**CITY OF WEST DES MOINES
PLAN AND ZONING COMMISSION COMMUNICATION**

Meeting Date: July 13, 2020

Item: Midtown Redevelopment, 1221 through 1261 8th Street– Approval of a Site Plan and Preliminary Plat to allow development of a commercial and residential vertical mixed-use development – JGC Holdings, LLC – SP-0004688-2020 and PP-004587-2020

PHASING PLAN

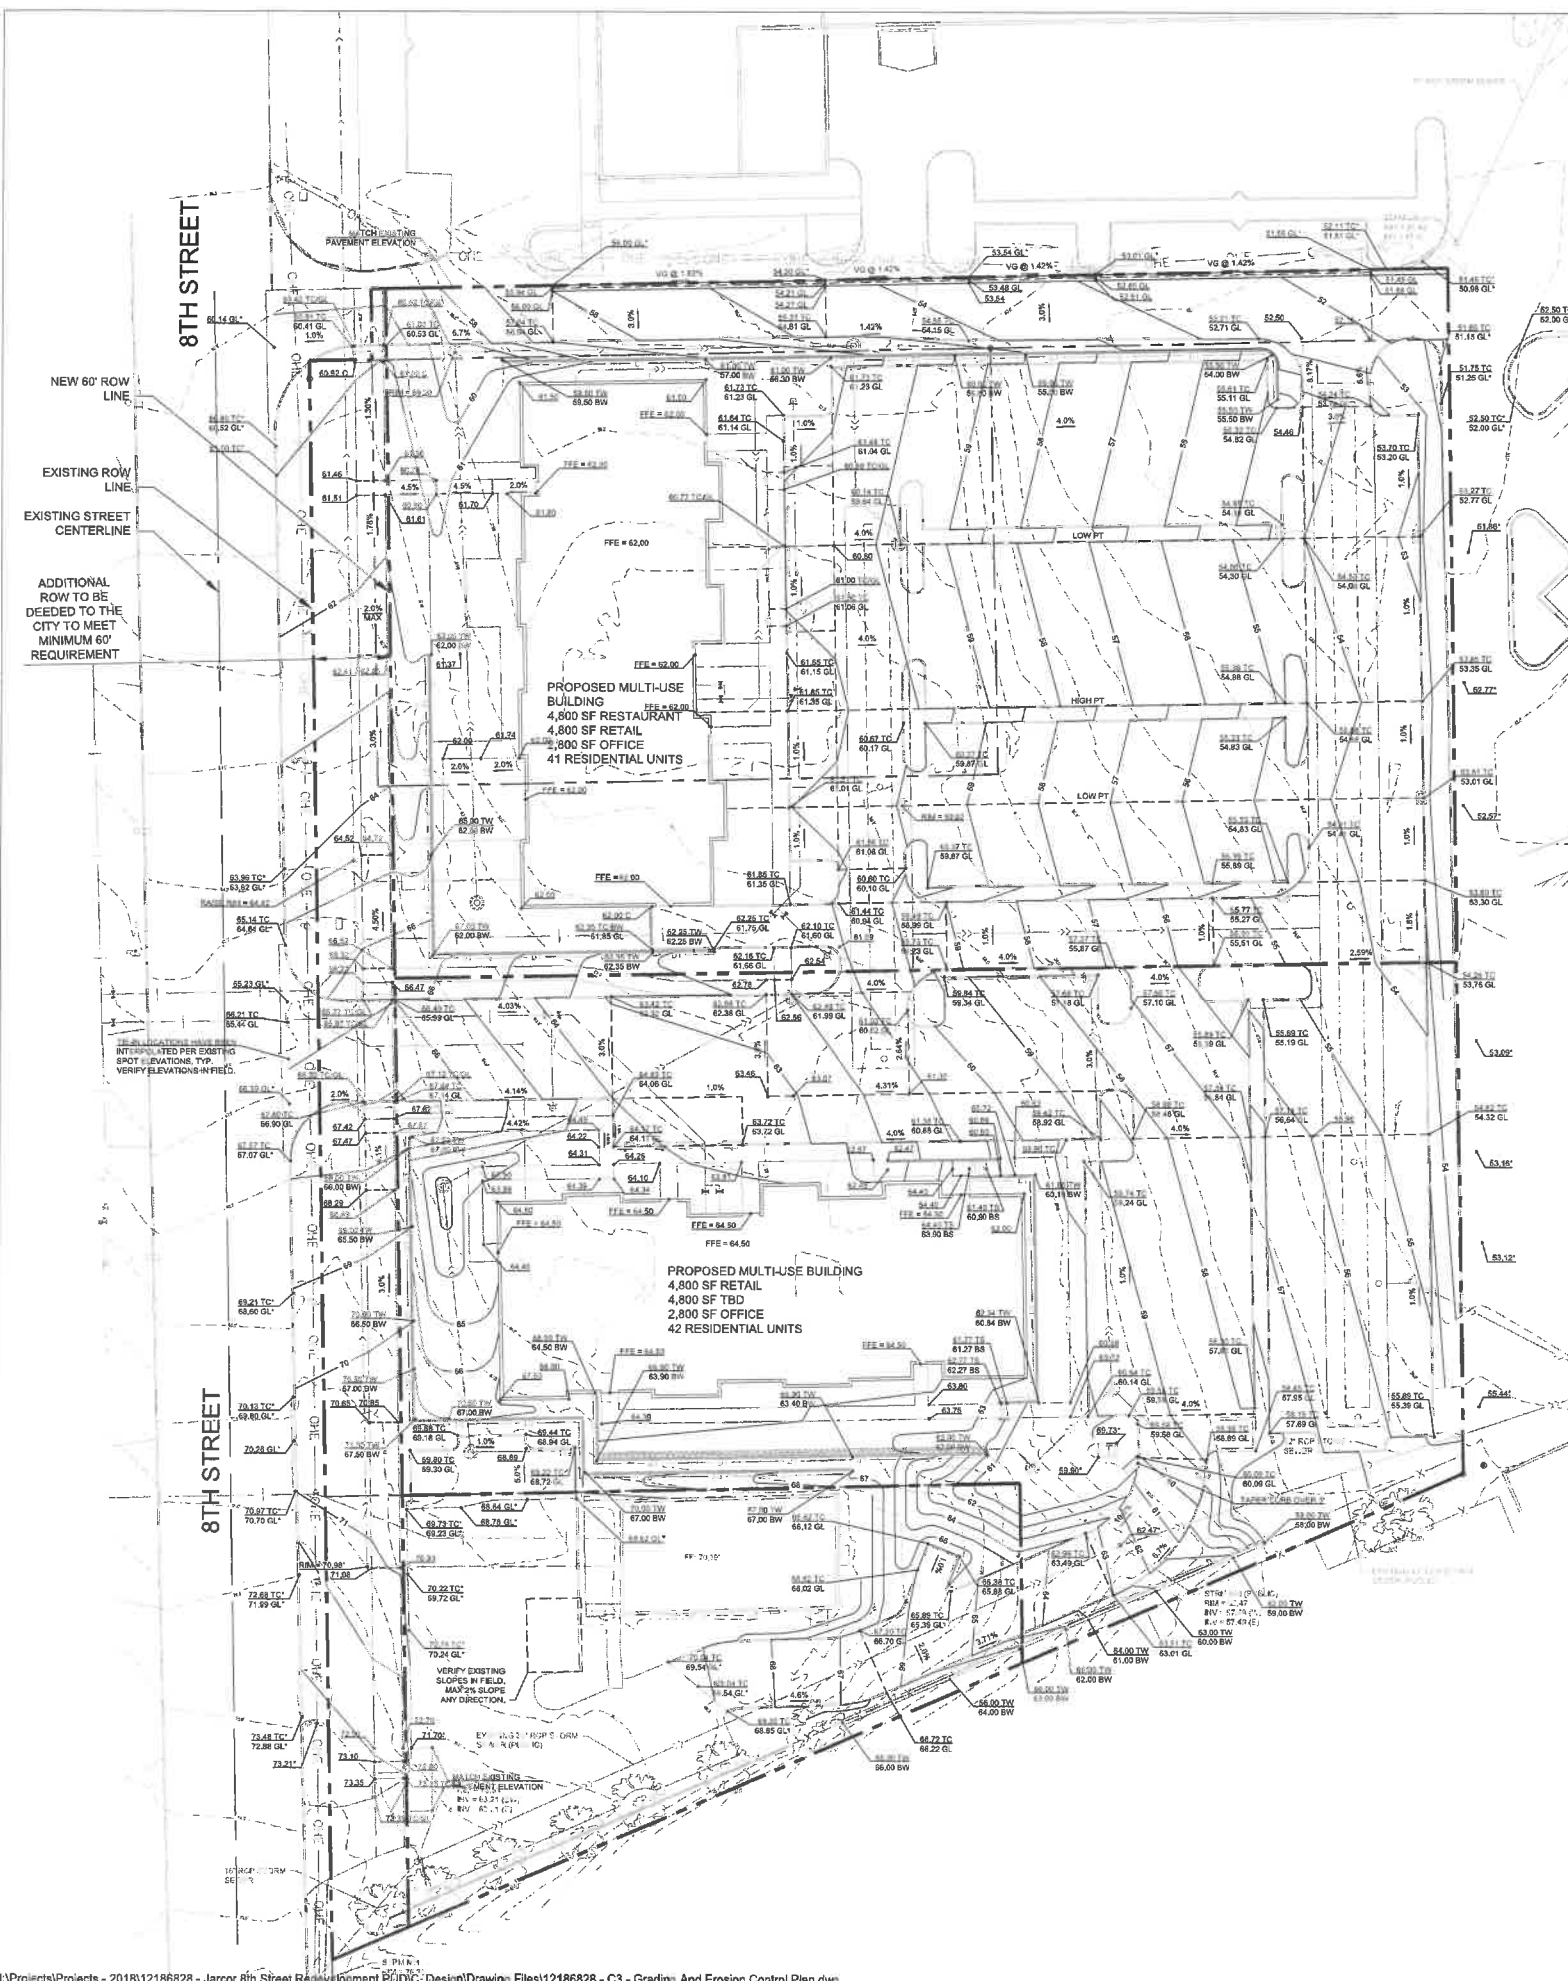
- **Project Phasing:** The applicant is proposing to develop the site in two phases. The timing of the phases will be back to back. The applicant wishes to have the northern building (phase one) occupied while they construct or finish the new southern building (phase two). The applicant has submitted a phased plan (Page C2.1 of Attachment B) that they are requesting is approved with the Site Plan. Staff is comfortable with the request and is recommending conditions that will allow for the phasing.

3. Applicant acknowledging and agreeing that in order to occupy buildings within the Phase One area, all site improvements, including pavement and ADA markings, sidewalks, buffers, landscaping and lawns within that identified phase area will need to be completed. For the purposes of determining the required improvements, Phases are illustrated on Attachment C of this report.
